# City of Medford

The Engineering Division received and reviewed a revised plan set (21 sheets) for the Winthrop Estates Definitive Subdivision (the Plan). The revision date is June 24, 2019. The Engineering Division issued a letter dated May 7, 2019 with comments on the original submission. The revised plan appears to address many of these comments; however, some open items remain.

WINTHROP ESTATES  
DEFINITIVE SUBDIVISION OF LAND  
MEDFORD, MASSACHUSETTS  
PREPARED FOR:  
WAYPOINT DEVELOPMENT  
5 BROADWAY SUITE 200B  
SAUGUS, MASSACHUSETTS

GT-1

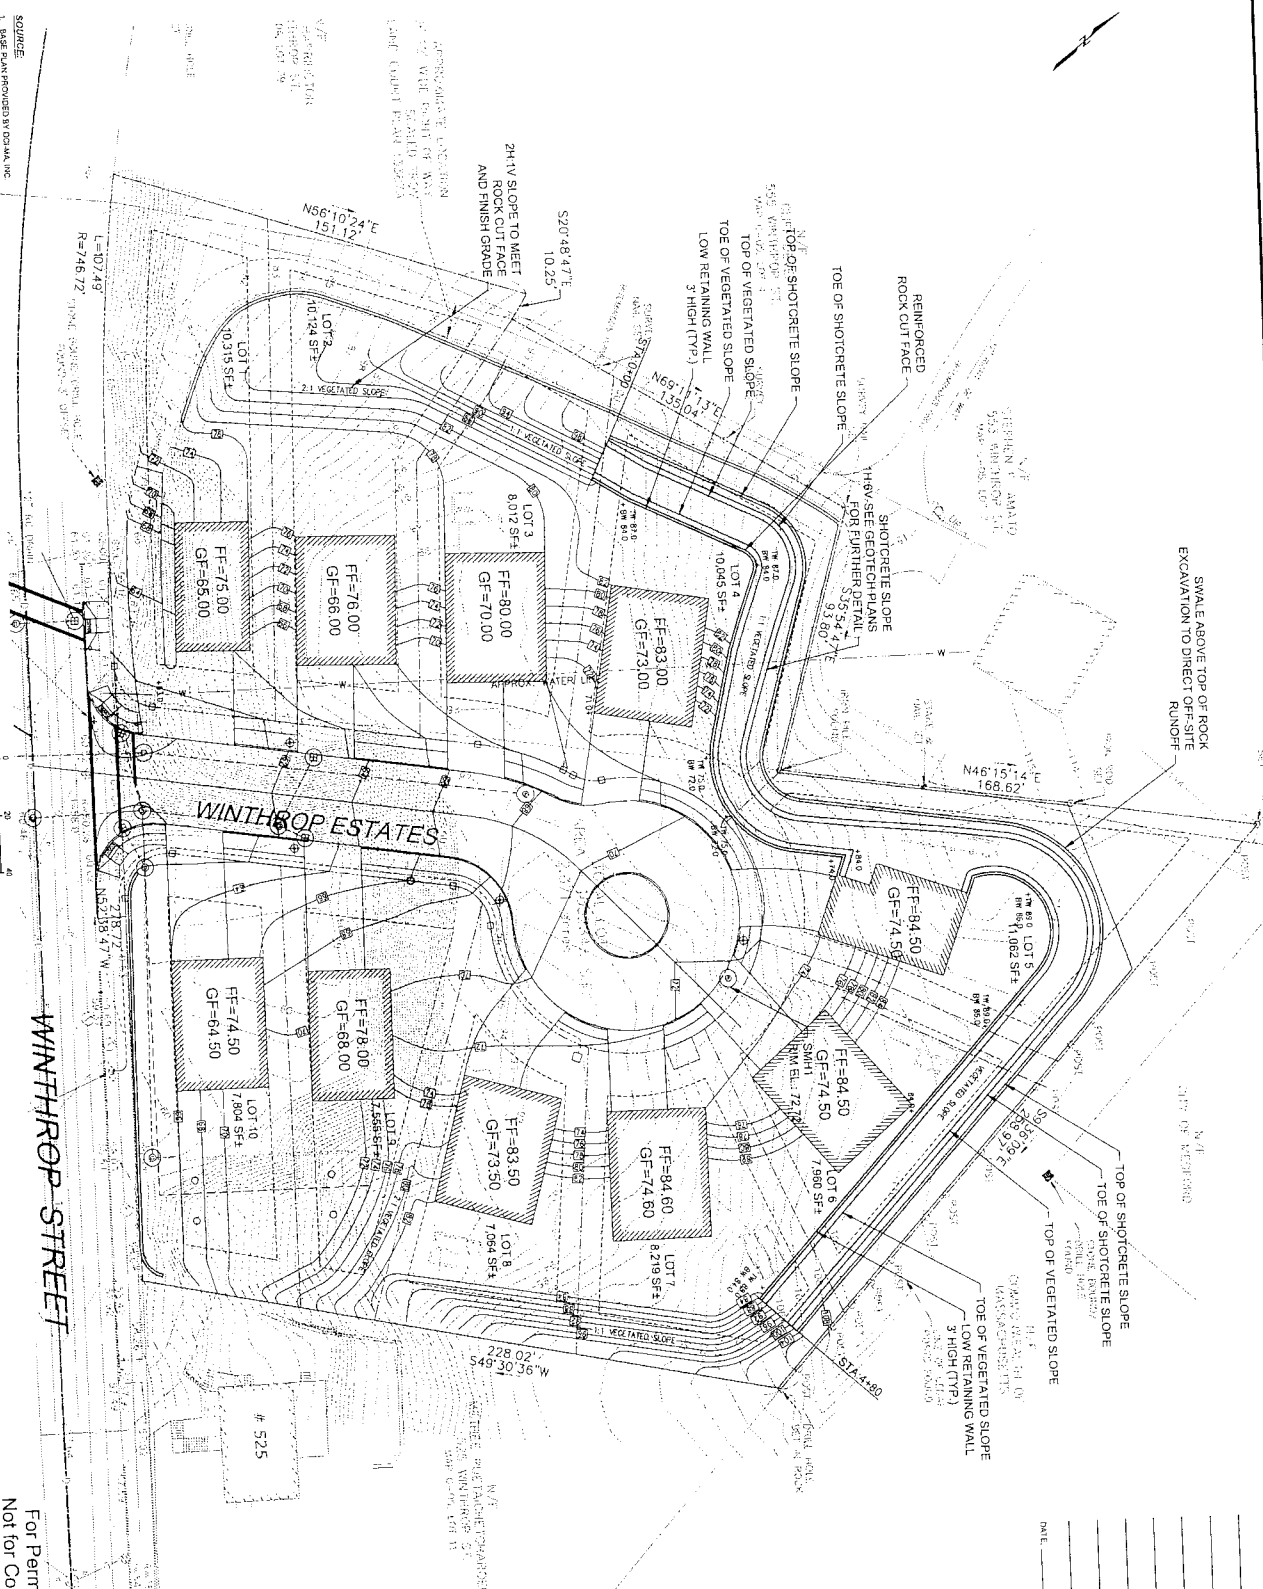
11. *The Plan includes requirements for "Rock Excavation, Rock Face Cleaning & Rock Dowel Installation". Note 2 under these requirements indicates "lifts". The Plan should be revised to include heights of the lifts required in each step of the construction process. This should include, but is not limited to, the maximum height of rock face prior to stabilization, and the height of vegetated slopes prior to stabilization.*

**The comment is not fully addressed. Please revise the Plan to include the height of vegetated slopes prior to stabilization.**

DCI Response: “(per Frank Leathers, GEI): Drawing GT-5, Section titled “Rock Excavation, Rock Face Cleaning and Rock Dowel Installation”, Note 2 – sentence has been added “Maximum excavation lift height shall be 9 feet below top of rock or lowest previously installed row of dowels.””

C6.1

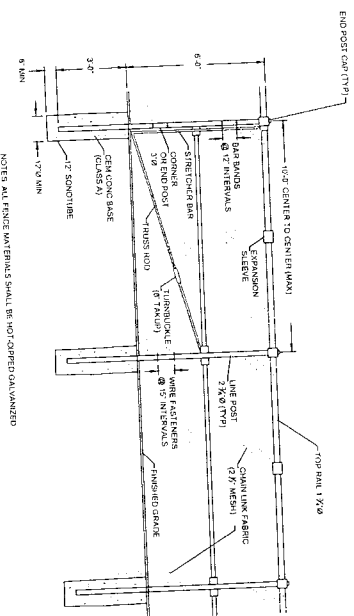
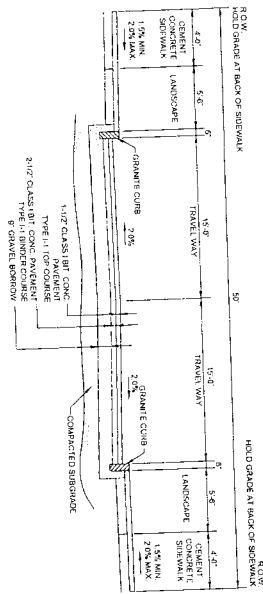
- 19f. Detail 10 on Sheet C6.1 indicates decimal values with no unit. Please revise accordingly.
- 19g. Detail 16 on Sheet C6.1 includes a guard rail. Please confirm that this design meets federal highway guard rail design standards.

- 19f. Detail 10 on Sheet C6.1 indicates decimal values with no unit. Please revise accordingly.

- 19g. Detail 16 on Sheet C6.1 includes a guard rail. Please confirm that this design meets federal highway guard rail design standards.

**PROPOSED SIGNAGE & STRIPING PLAN**  
C6.3  
DR BY: SSS  
CHK BY: WCKES  
PROJ NO: 2017-001  
DATE: 06/01/17  
SCALE: 1" = 10'

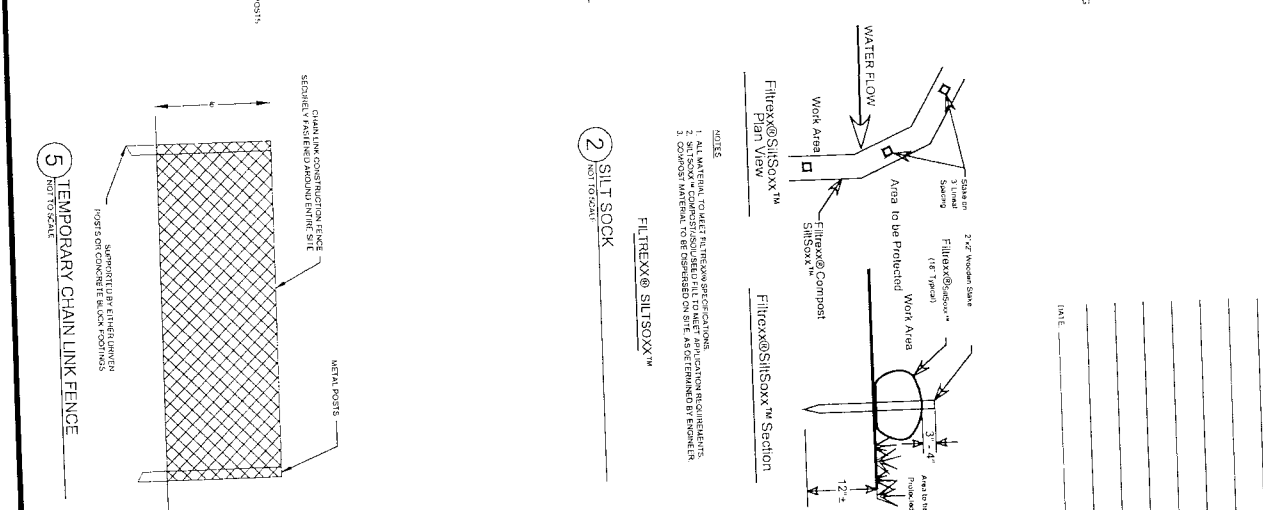
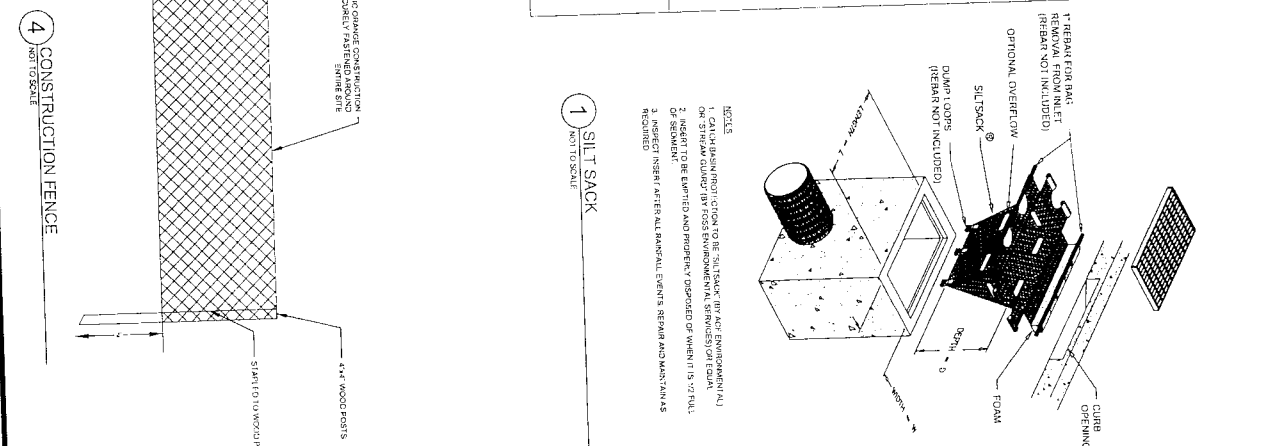
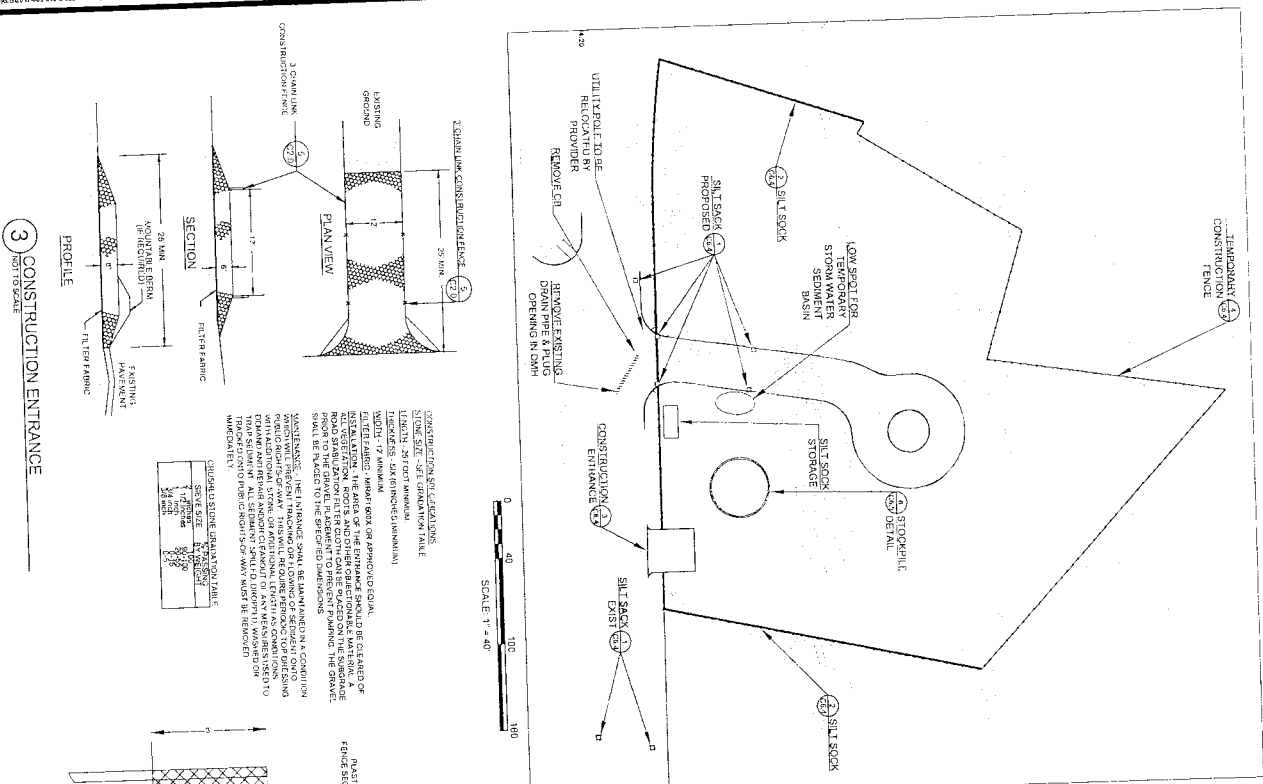
- 19a. Detail 2 on C6.3 is titled "Wheelchair Ramp – Winthrop Street"; however, it is tagged at Lorraine Road in plan view. Please clarify and revise as needed.

- 19a. Detail 2 on C6.3 is titled "Wheelchair Ramp-Winthrop Street"; however, it is tagged at Lorraine Road in plan view. Please clarify and revise as needed.
